CITY OF ALBUQUERQUE

RE: 4000 Ellison NE
4000 Ellison Street NE
Grading and Drainage Plan
Engineer's Stamp Date: 1/17/22
Hydrology File: D17D074

Based upon the information provided in your submittal received 1/4/2022, the Grading & Drainage Plan **is not** approved for Building Permit. The following comments need to be addressed for approval of the above referenced project:

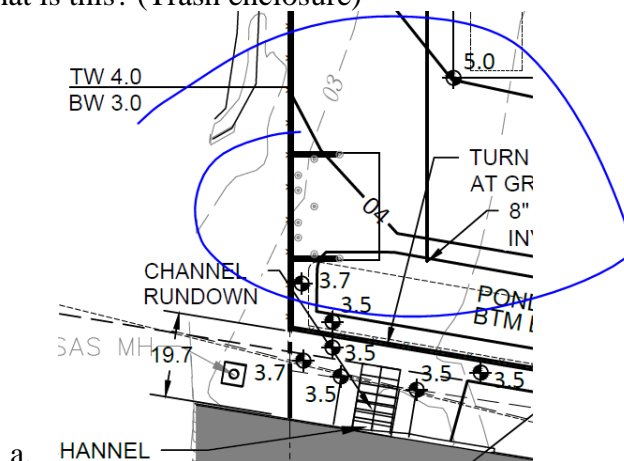
1. Please provide survey points.
2. Provide a detail of the retention pond and clearly show a defined area for these. Determine if fencing is needed around the pond.
 - a. Will there be a barrier for the pond at the South Pino Channel?
 - b. This site will require AMAFCA review for their input.
3. Is PNM okay with constructing a structure etc... within the shown easement?
 - a. Please call out the document number and filing date. For both Easements and note are they existing or proposed?
4. What is this? (Trash enclosure)

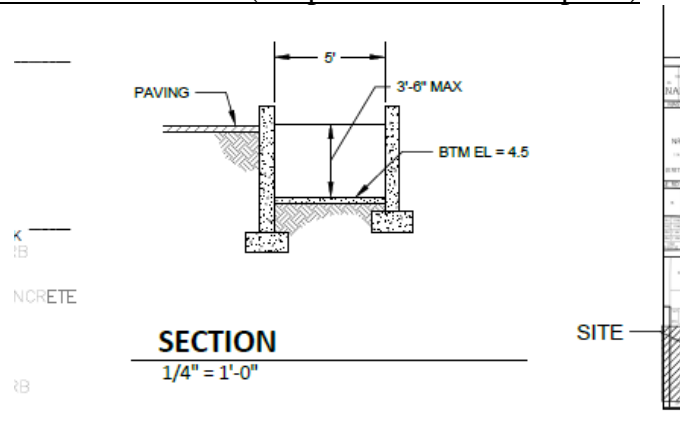
5. Please clearly show where this section is taken to relate to the plan (e.g. section A-A).
What is this a section of? (see picture below from plans)

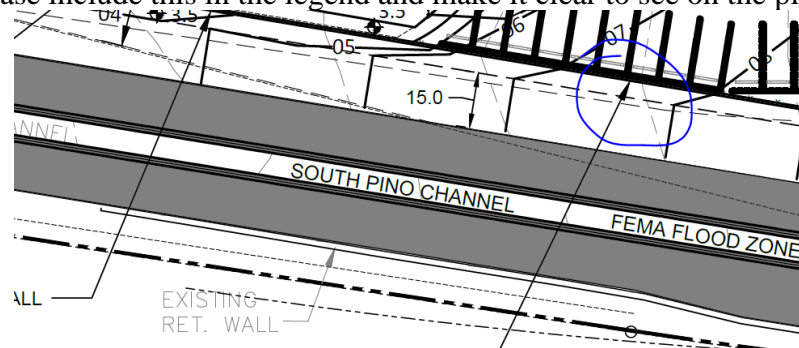
- a. Please identify a basin delineation.
7. I see a call out for a CMU wall but it is not clear what line on the plans the leader points to. Please include this in the legend and make it clear to see on the plans.
